RE: SECTION 4.55(1A) MODIFICATION APPLICATION TO SSD 10224 IN RELATION TO THE NEW PRIMARY SCHOOL AT EDMONDSON PARK, BUCHAN AVE, EDMONDSON PARK

This planning statement has been prepared for School Infrastructure NSW (SINSW) by GYDE Consulting to accompany an application made under Section 4.55(1A) of the *Environmental Planning and Assessment Act, 1979* (the Act) to modify the consent issued in respect of SSD 10224.

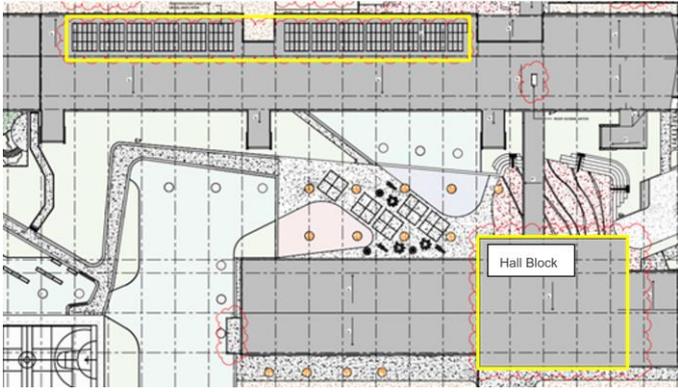
- Relocating the approved solar panels from the roof of Block B (Hall and COLA building) to the roof of Block A. An additional 20kW of photovoltaic panels are also proposed to be added to the system resulting in an overall capacity of 90kW.
- The addition of three mechanical enclosures along the Faulkner Way frontage. The enclosures will accommodate condenser units for the air-conditioning system. The walls of the enclosures are to be constructed of sound attenuating material and each will have a gate for access. The northern enclosure observes a setback of 750mm and the other enclosures observe a setback of 1050mm from the boundary, both to allowing landscaping to be provided between them and the street.

- Northern enclosure: 9.1m (L) x 5.3m (W) X 1.8m (H) – note the floor level of this enclosure sits 0.9m below the footpath level
- Central enclosure: 11.3m (L) x 4.9m (W) x 1.8m (H)
- Southern enclosure: 11.6m (L) x 4.9m (W) x 1.8m (H).
- Modification of the landscape design along the Faulkner Way frontage to accommodate the proposed mechanical enclosures. Importantly, the total number of trees along the frontage is retained.
- The addition of a mechanical enclosure on the southern end of Block B.
- The addition of a small mechanical enclosure adjacent to the hall/out of school hours care on the south-eastern elevation of Block B.
- The addition of a roof access hatch to Block A to facilitate servicing of the PV array.

Figure 4: Height of Solar Panel within highlighted area. Height limit in green dash (Source: TKD architects)

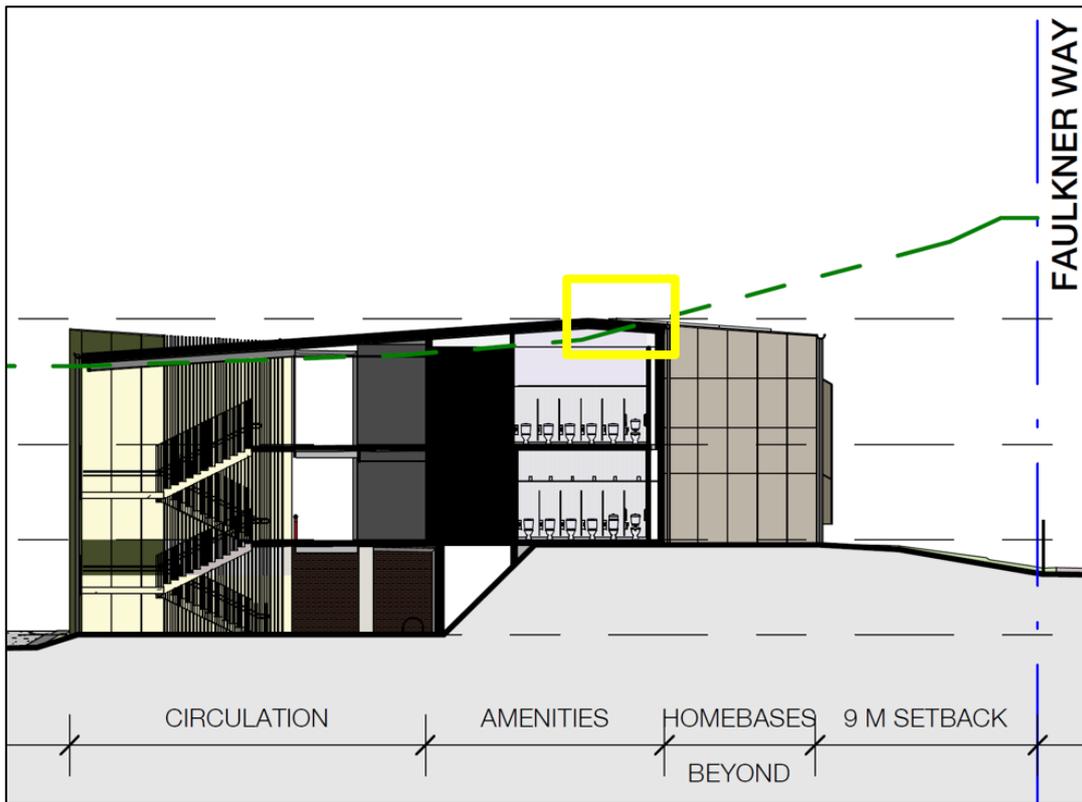
Clause 18 - Height of Buildings (Appendix 1) of the Precincts – Western Parkland City SEPP applies a 15m height control to the site. Building A as approved exceeds the height limit by between 0.5 - 1.6m along the ridge of the roof. The addition of the solar panels on the western side of the roof will result in a minor increase in the extent of the breach. It is important to note that the breach is limited to a small section along the eastern edge of the panels, closest to the ridgeline, as is shown in Figures 4 and 5 below.

Pursuant to Clause 3.43 of the TISEPP, "development consent may be granted for development for the purpose of a school that is SSDA even though the development would contravene a development standard imposed by this or any other EPI under which the consent is granted." Notwithstanding, the proposed contravention to the height standard is reasonable for the following reasons:

- the proposed change does not alter the scale of the building or its height relationship to adjoining residential development
- there is no change in overshadowing
- the solar panels will be largely imperceptible from the public domain.
